PLANNING & ZONING CASE NO. SP2026-022

RE : Site Plan Submittal : Chewters Chocolates
2911 Discovery Boulevard
Lot 1, Block B Rockwall Technology Park

SUBJECT: SP2026-022; *Amended Site Plan for Chewters Chocolates*

PROJECT NUMBER: SP2026-022
PROJECT NAME: Amended Site Plan for 2911 Discovery Blvd
SITE ADDRESS/LOCATIONS: 2911 Discovery Boulevard, Rockwall, TX, 75032
CASE CAPTION:

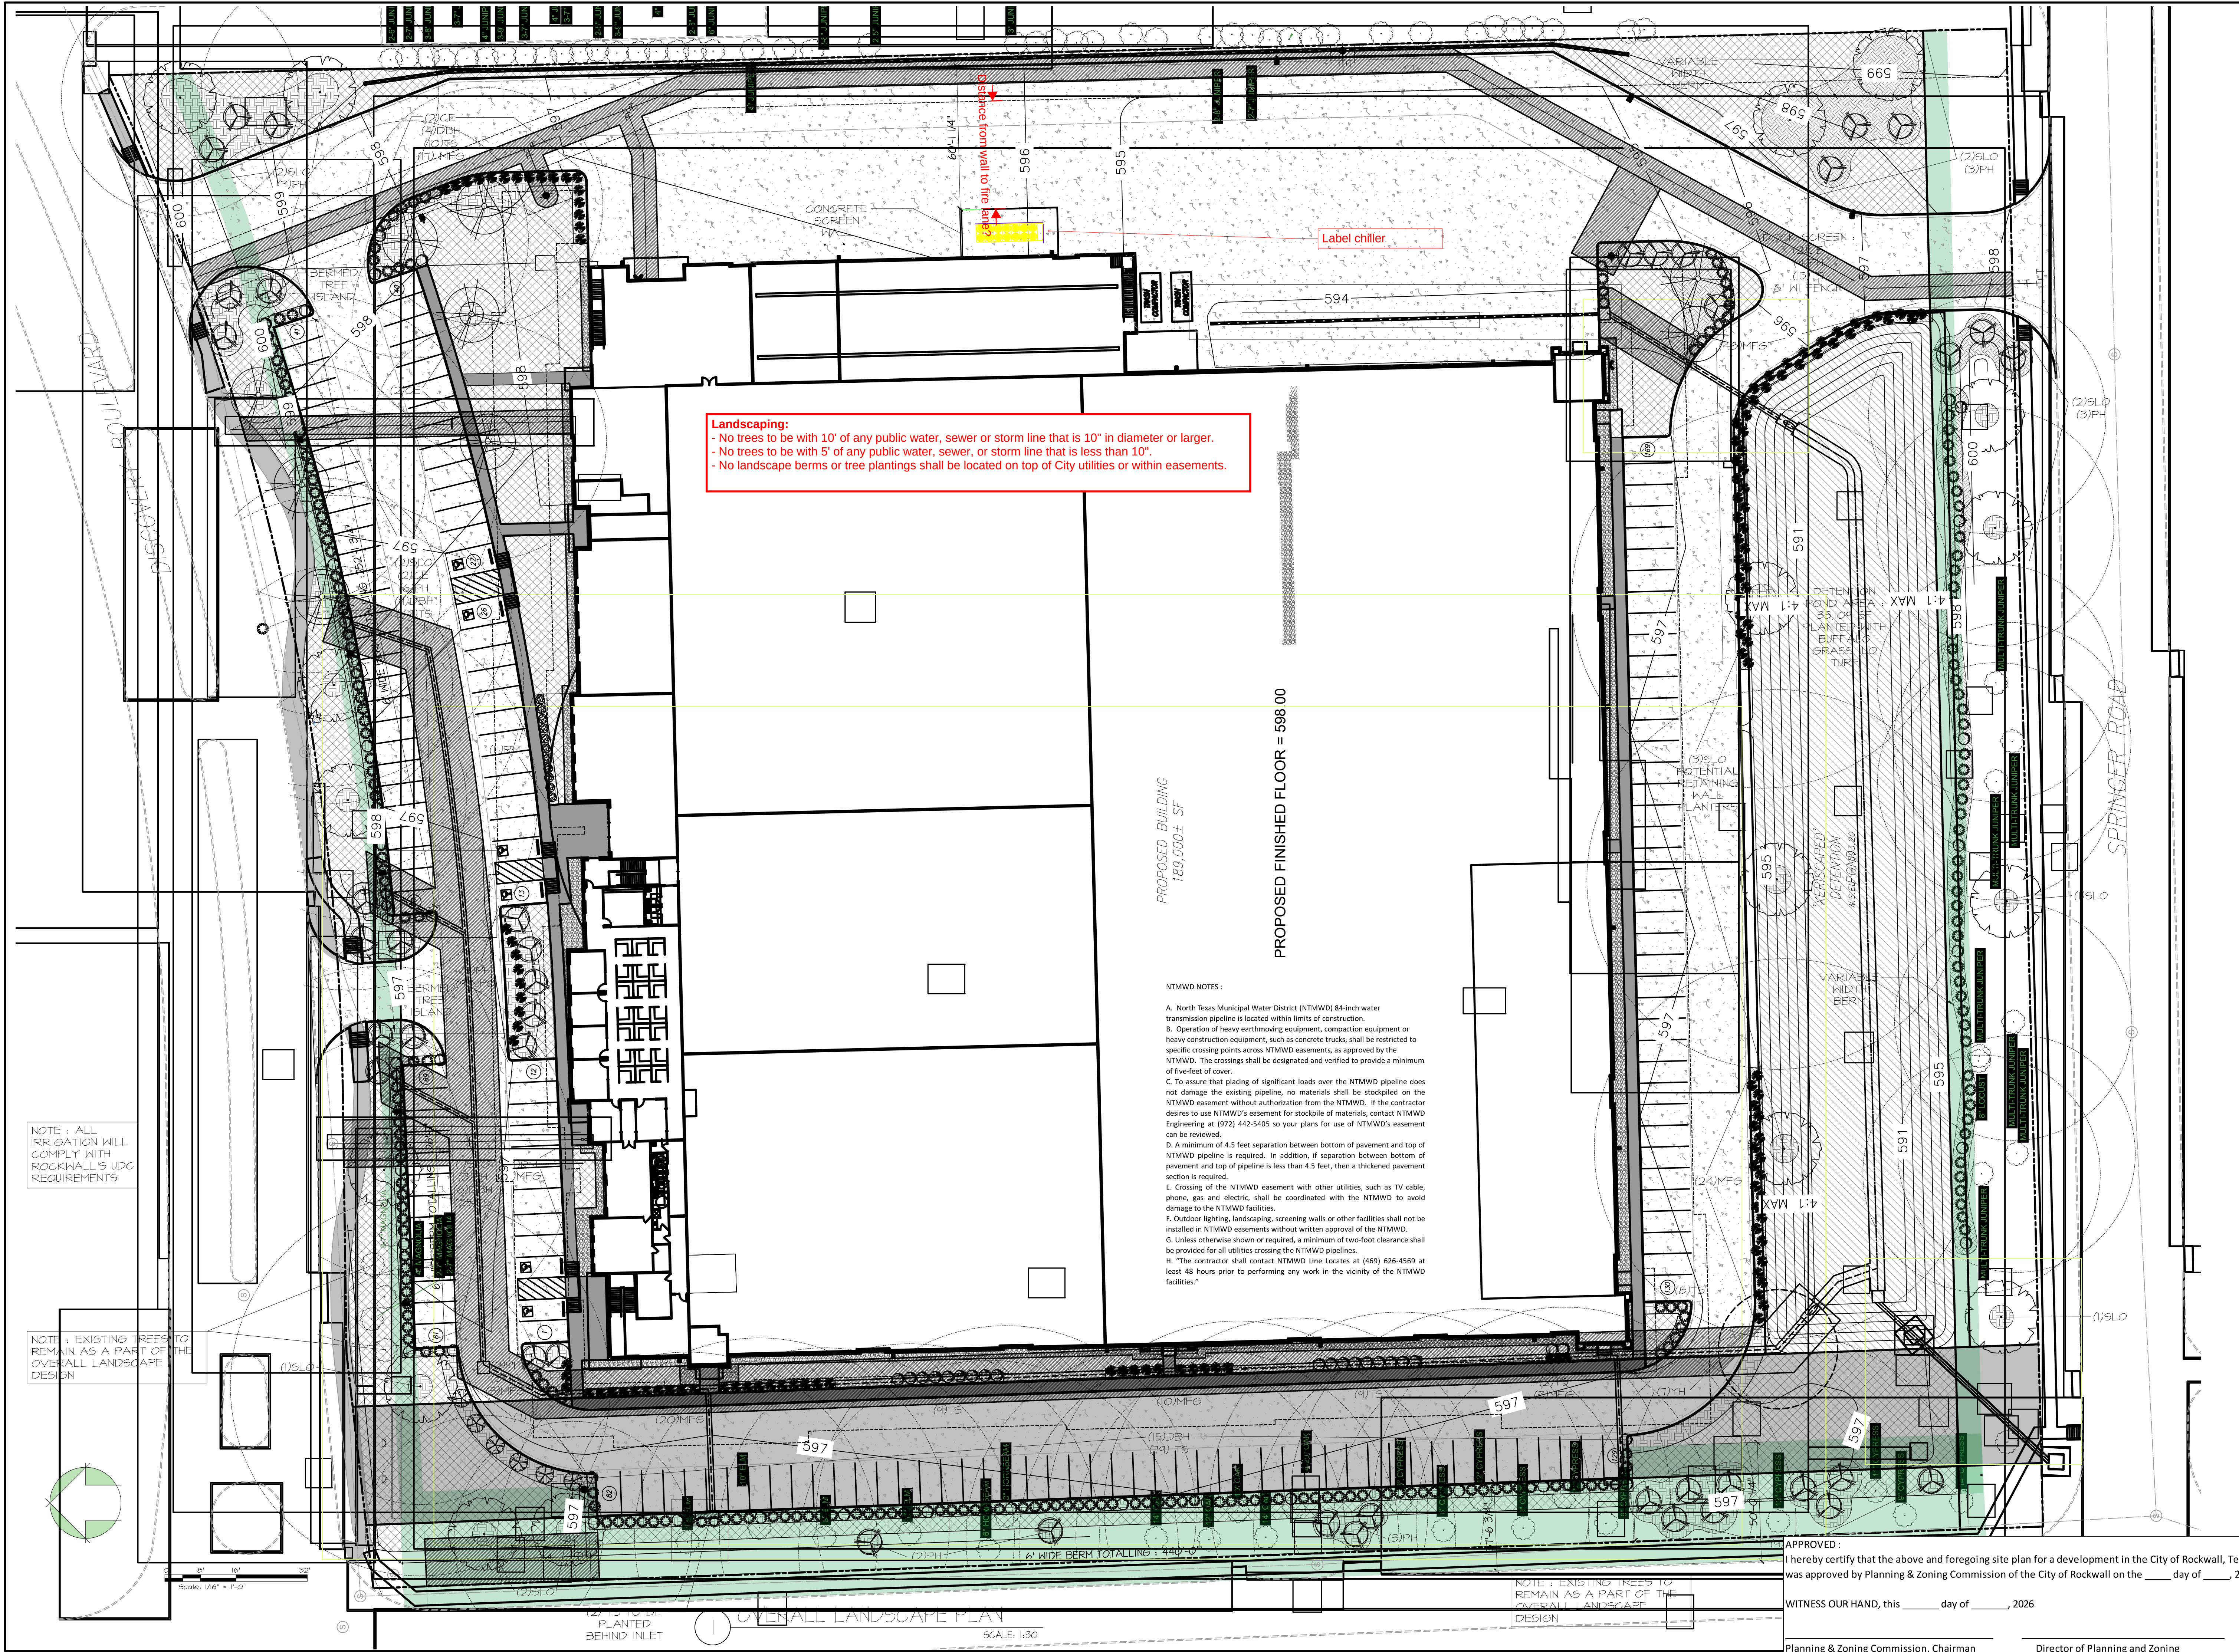
06/15/2026: Recommendation only

There are better varieties of Bermudagrass that are more cold, drought, shade and wear tolerant than Common Bermuda such as Tif Tuf and Tahoma 31
